## SERVICE LETTER 275

### Fire Boss Finlet Mount Gussets

| Aircraft Makes/Model(s):       | Float Model(s): | Compliance: Mandatory                   | By: MAS                      |
|--------------------------------|-----------------|-----------------------------------------|------------------------------|
| Air Tractor<br>AT-802, AT-802A | 10000A          | Part Number: 1013045<br>Date: 9/11/2026 | Approved: DRH<br>Revision: A |

**Figure 1**

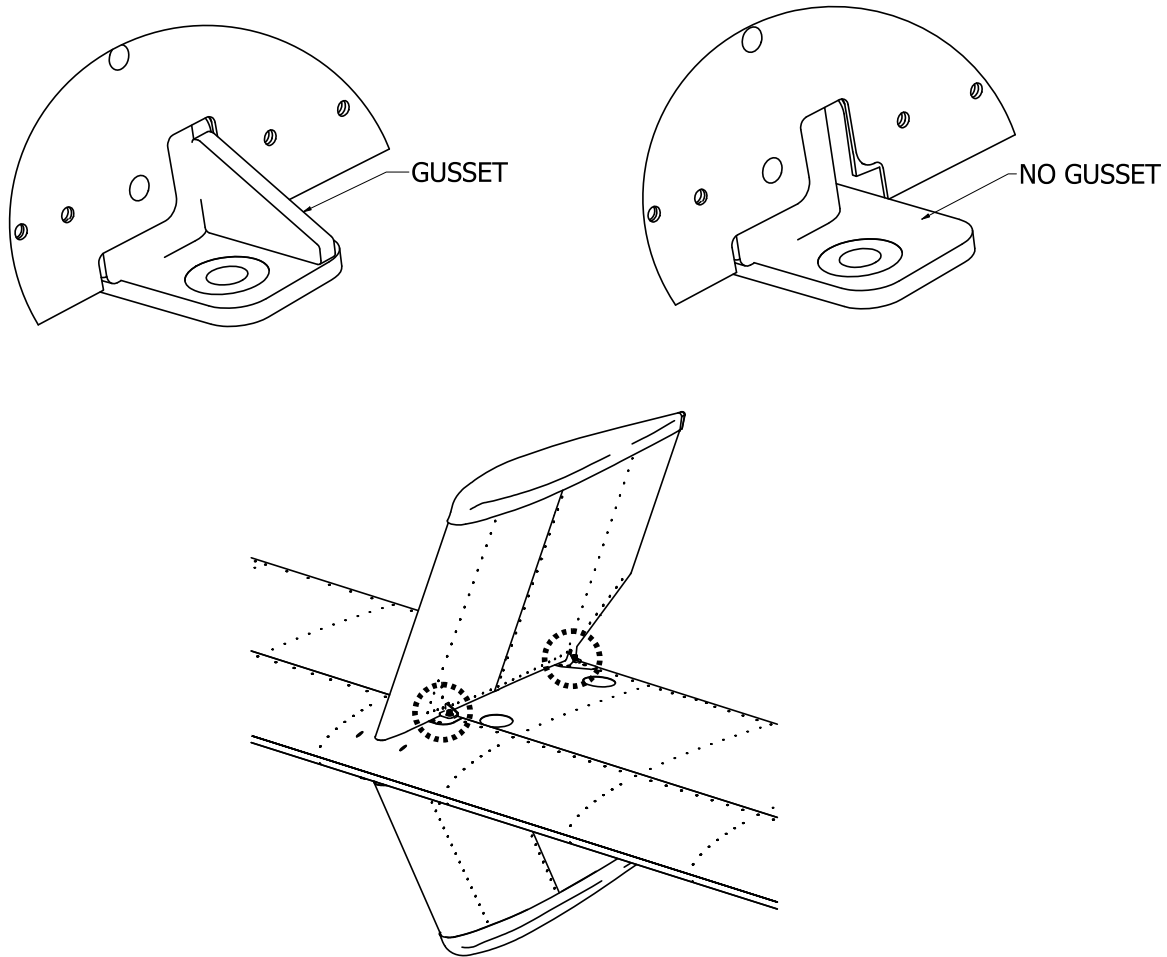
Field observations and analysis have confirmed the need for gussets at finlet mounts.

Inspect for presence or absence of finlet mount gussets and, if absent, install new finlet assemblies per the work instructions in this service letter. Because assembly methods, tolerances, installation tooling, etc., have changed over the years, it is very unlikely that older finlet assemblies can be reworked and reused.

1. Position and prepare aircraft for safe maintenance.
2. Inspect all four finlets for mount gussets, checking both forward and aft mounts. See Figure 1. Note that there are finlet mounts with welded gussets and others that are machined from billet material. Both are acceptable. If all (8) finlet mounts include gussets, skip to Aircraft Closing and Return to Service section, otherwise continue to step 3.

3. Remove all finlets which lack gussets at any mount location, removing access covers as needed.
4. Install S2145-1 rubber channel to "bottom" of replacement finlets to create seal against horizontal stabilizer. Attach with 1300L adhesive, or equivalent.

5. Secure finlets to horizontal stabilizer with existing bolts and washers and new self-locking nuts (item 3). Verify that the countersunk washers are placed under the bolt head. Torque to 50-70 in-lb.
